## **PINOLE PLANNING COMMISSION MEETING AGENDA**

**August 10, 2026**

PINOLE SHORES PHASE 2

**Figure 1: Project Location**

**L-1.1**  
TITLE OF DRAWING:  
LANDSCAPE

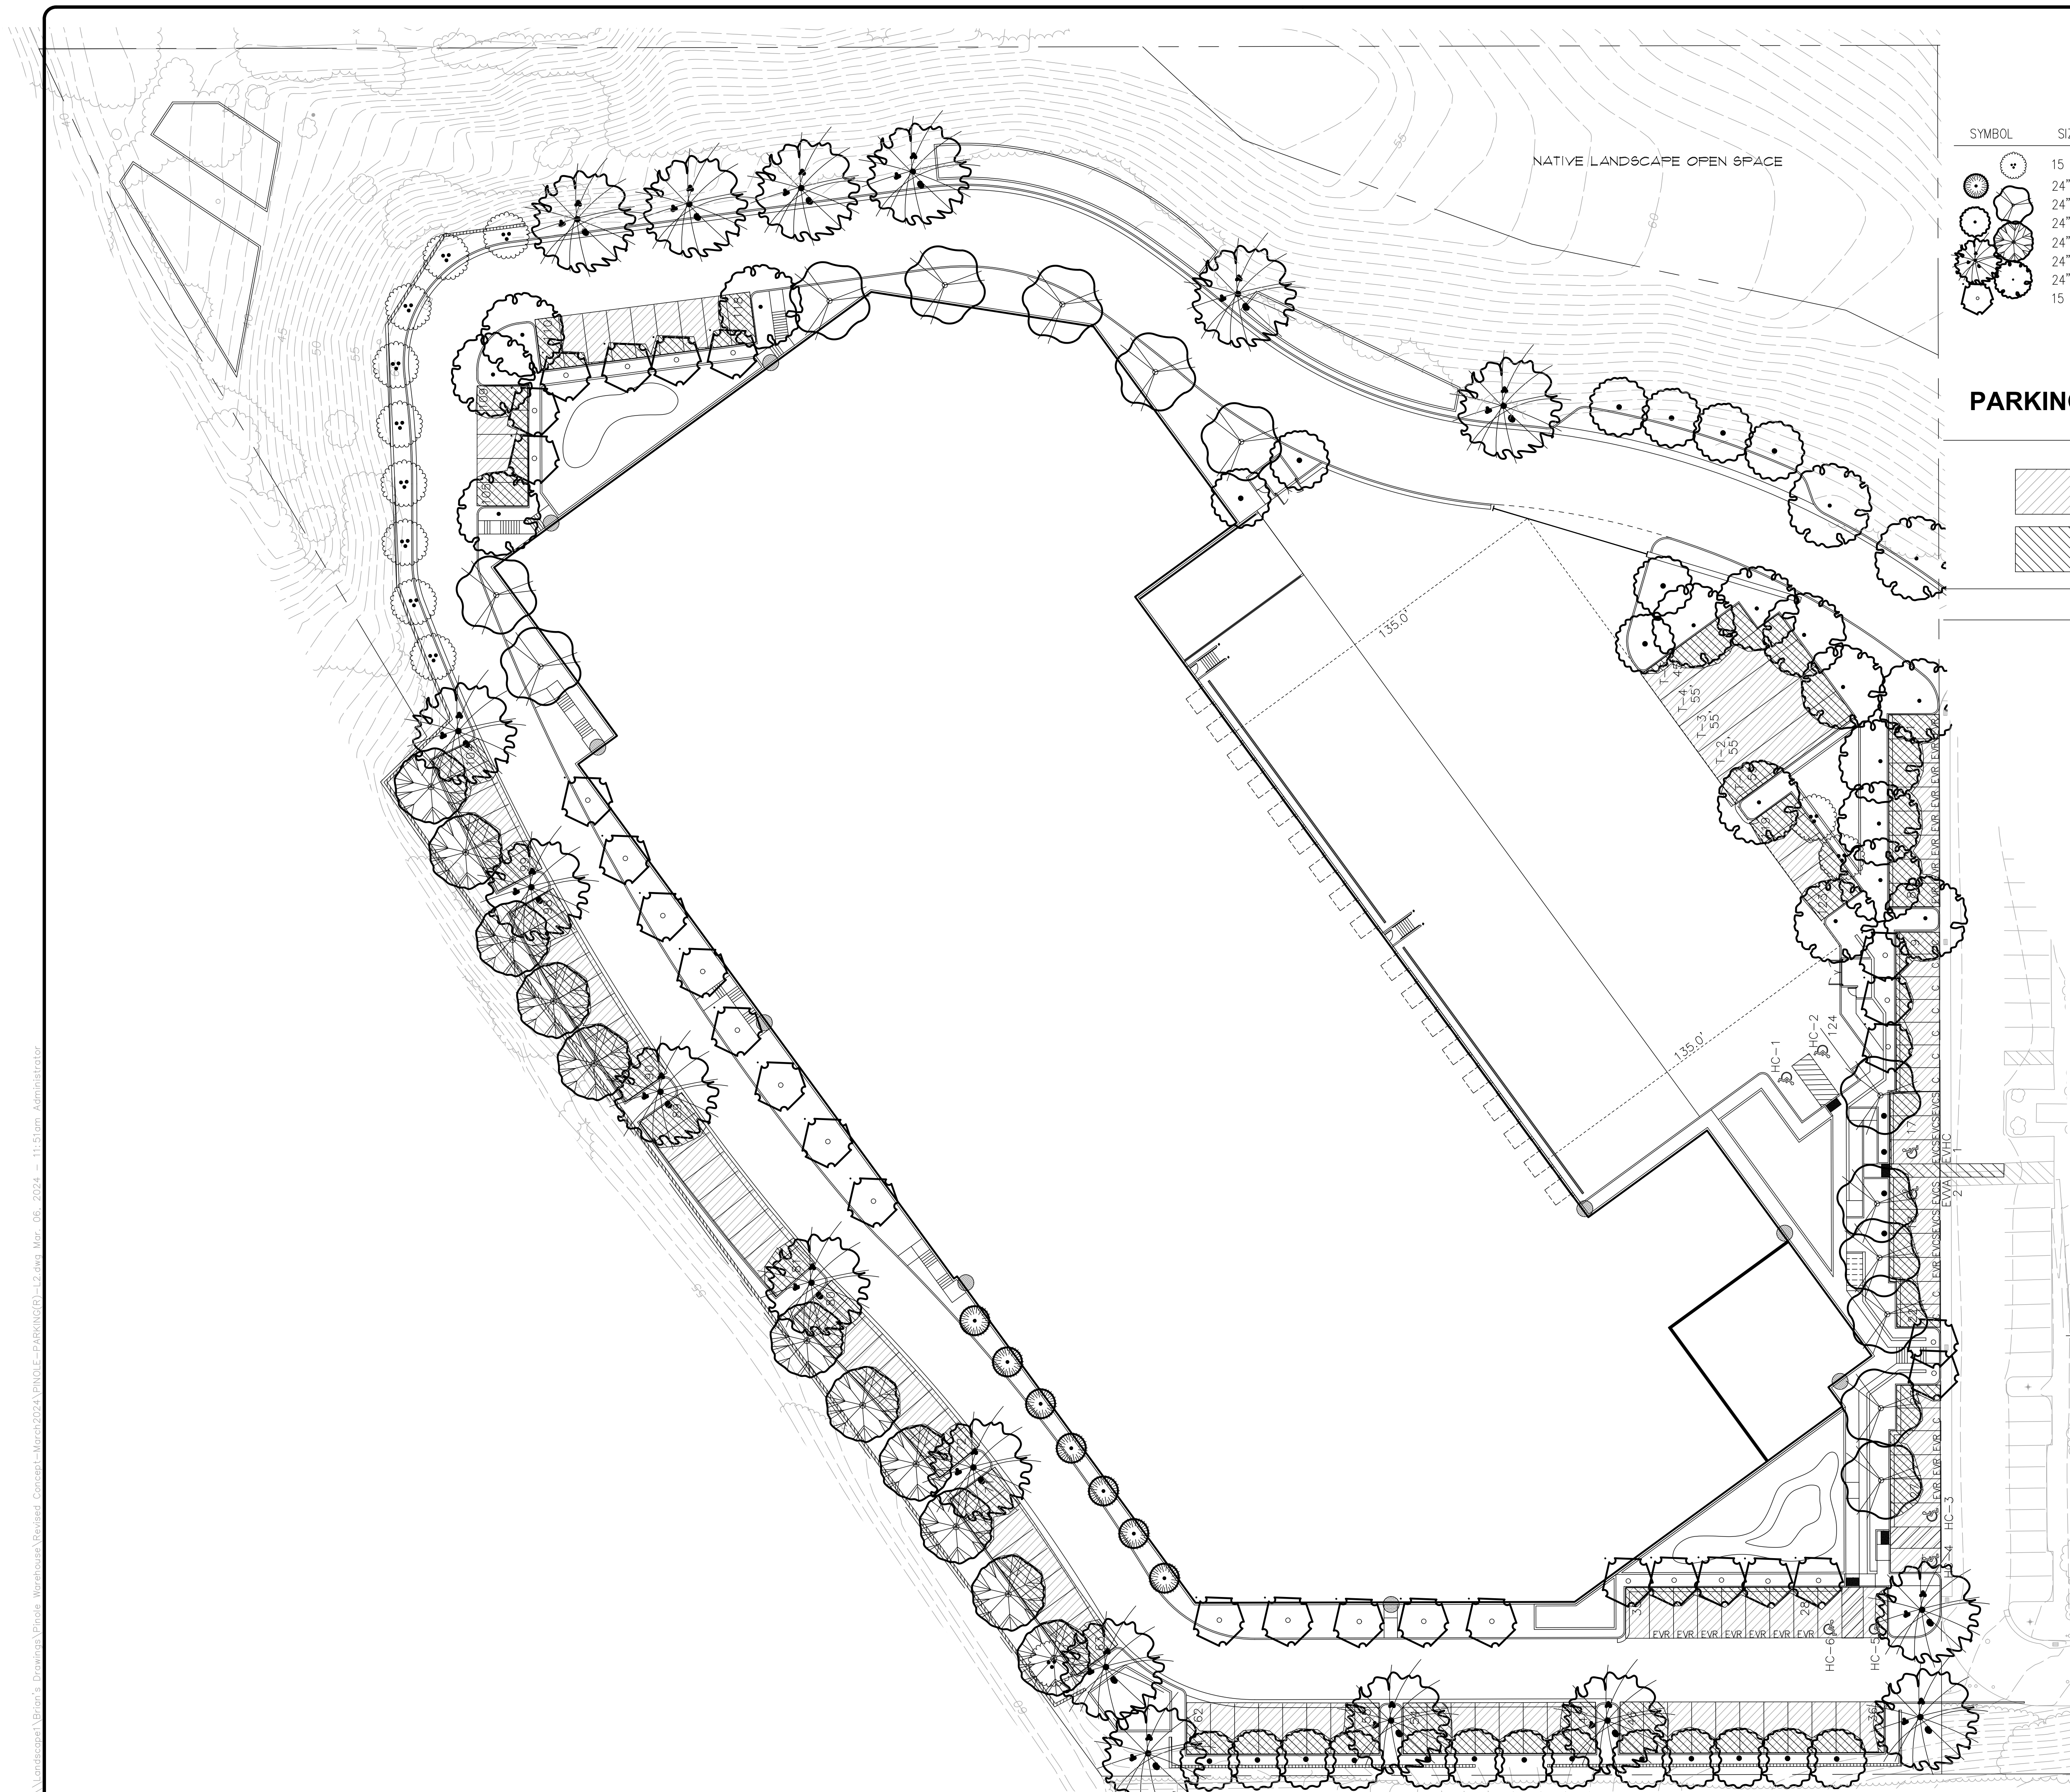
**CD-15: Page L-1.1- Should show the following:**

*Plan has been renamed, please see sheet L-1.1.*
